ROOF REPLACEMENT

**DR. HELEN BALDWIN MIDDLE SCHOOL
45 WESTMINSTER ROAD
CANTERBURY, CT 06331
STATE PROJECT #022-0016 RR**

S/P+A PROJECT NO. 16.081

DATE: July 6, 2018

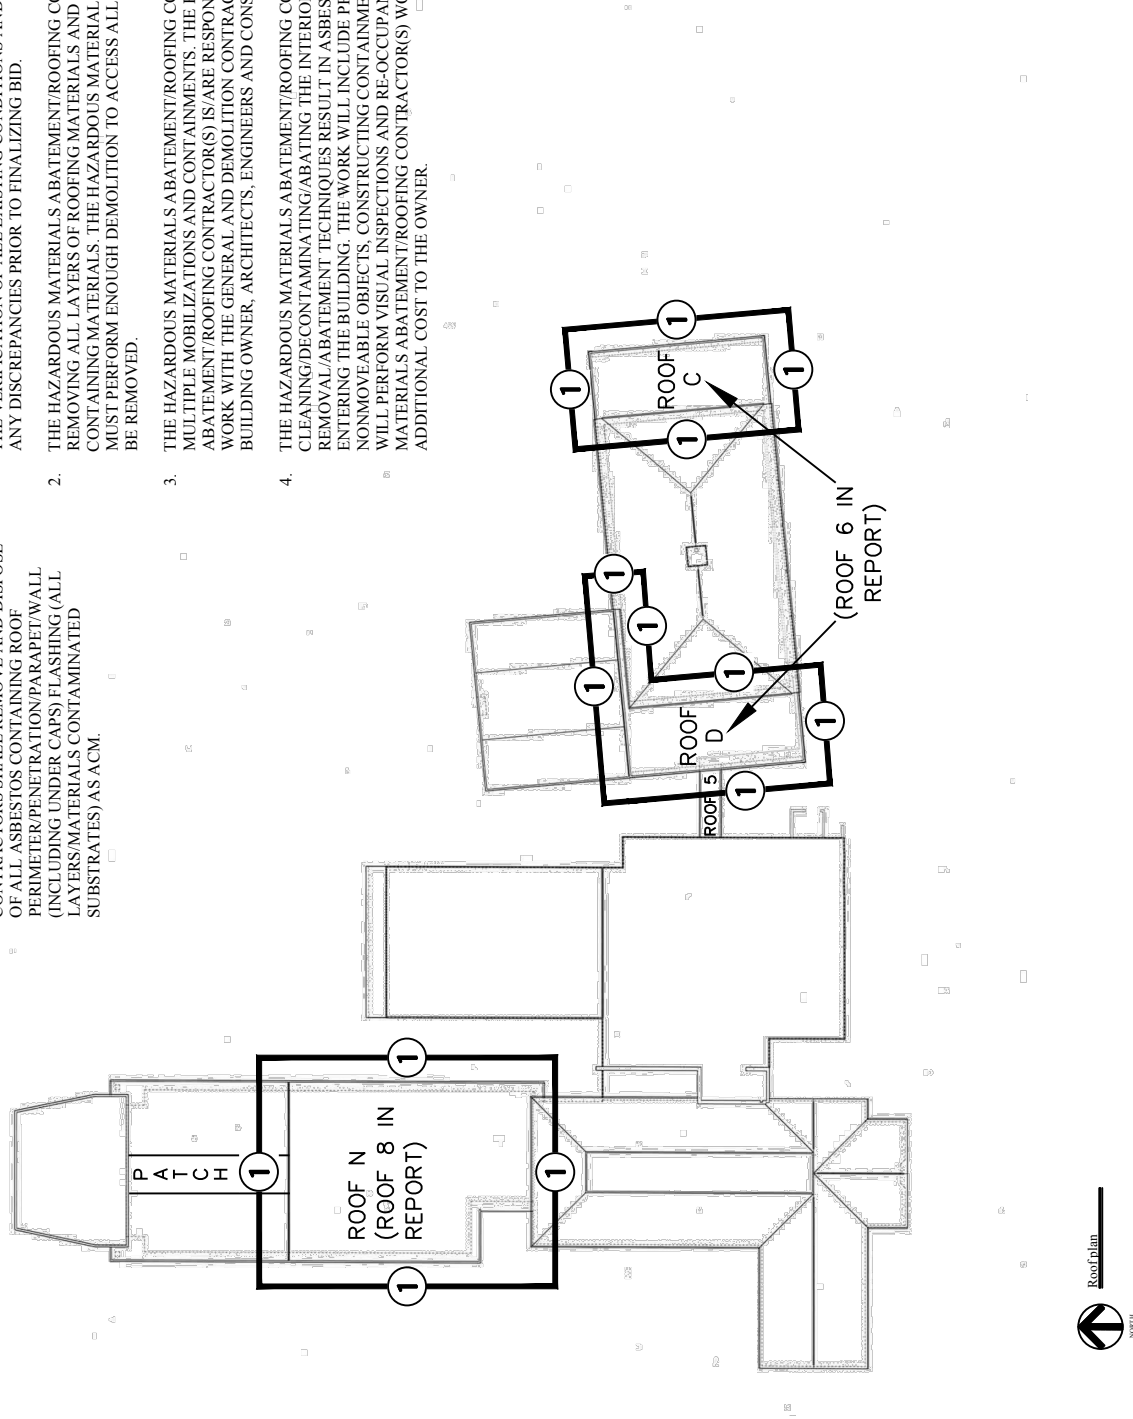
- DRAWING HM-01, HAZARDOUS MATERIALS ABATEMENT PLAN has been added and is attached as part of this addendum. Drawing is 8½” x 11” and Not to Scale.

HAZARDOUS MATERIALS ABATEMENT NOTES:

1. THE HAZARDOUS MATERIALS/ROOFING CONTRACTORS SHALL REMOVE AND DISPOSE OF ALL ASBESTOS CONTAINING ROOF PERIMETER/PENETRATION/PARAPET/WALL (INCLUDING UNDER CAPS) FLASHING (ALL LAYERS/MATERIALS CONTAMINATED SUBSTRATES) AS ACM.
